**Subject: Vermont Yankee Nuclear Power Station
License No. DPR-28 (Docket No. 50-271)
Technical Specification Proposed Change No. 262
Alternative Source Term
Second Response to Request for Additional Information**

**VERMONT YANKEE NUCLEAR POWER STATION
ALTERNATIVE SOURCE TERM
RESPONSE TO REQUEST FOR ADDITIONAL INFORMATION**

RAI No. 6

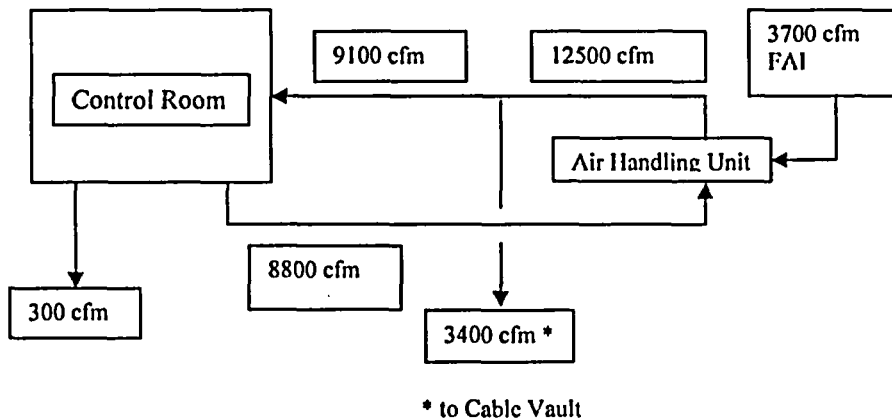
- a. Have you performed control room envelope inleakage testing? If so, what was the result, and how does that compare to the assumption of 3700 cfm of unfiltered inleakage?*
- b. Have you determined how the dose results of each of the postulated DBAs would be affected by assuming manual control room isolation occurs with a lesser unfiltered inleakage rate than currently assumed? A greater unfiltered inleakage rate?*

The design of the Vermont Yankee Control Room ventilation system does not have High Efficiency Particulate Air (HEPA) or charcoal filtration. During normal operation, the ventilation system has a fresh air intake of 3700 cfm. However, the ventilation system is designed to supply the Control Room with about 2700 cfm of fresh air (i.e., $(9100/12500) \times 3700$) and the remaining fresh air is supplied to other building locations. This configuration is depicted on the following sketch.

A "recirculation" ventilation mode exists where fresh air intake (FAI) is eliminated. However, placing the Heating Ventilation and Air Conditioning (HVAC) system in recirculation mode requires manual operator action that is controlled by procedure. The Control Room ventilation system is placed in recirculation mode for some conditions including high radiation.
